CITY OF ALBUQUERQUE

Re: 6805 Academy Parkway West, Interior Remodel Phase 1
6805 Academy Parkway West, 87124
30-Day Temporary Certificate of Occupancy
Transportation Development Final Inspection
Engineer's/Architect's Stamp dated 8-8-19 (E17D073)
Certification dated 2-18-20

SITE PLAN

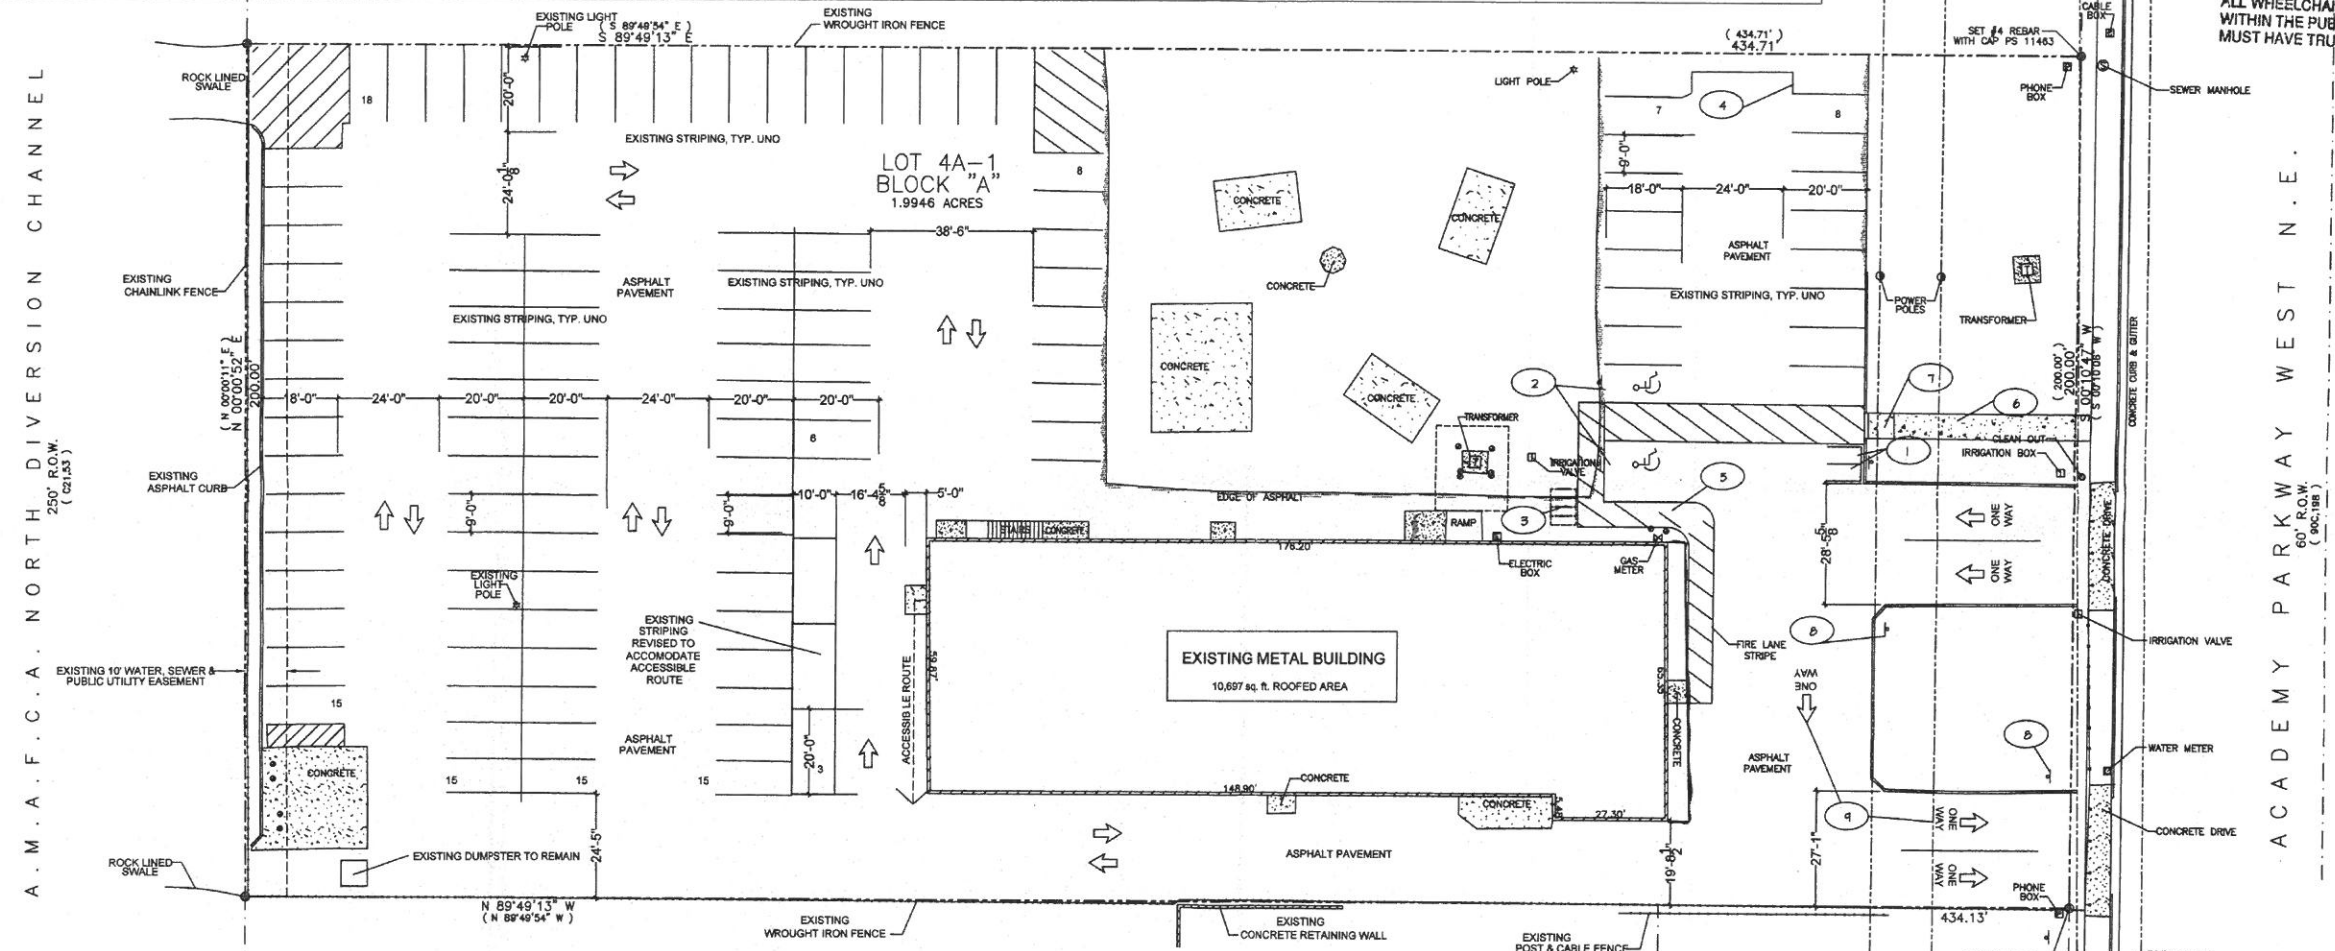
- Please relocate bike rack to location on approved TCL. Current location not within standards. Please see attached bike rack standards.
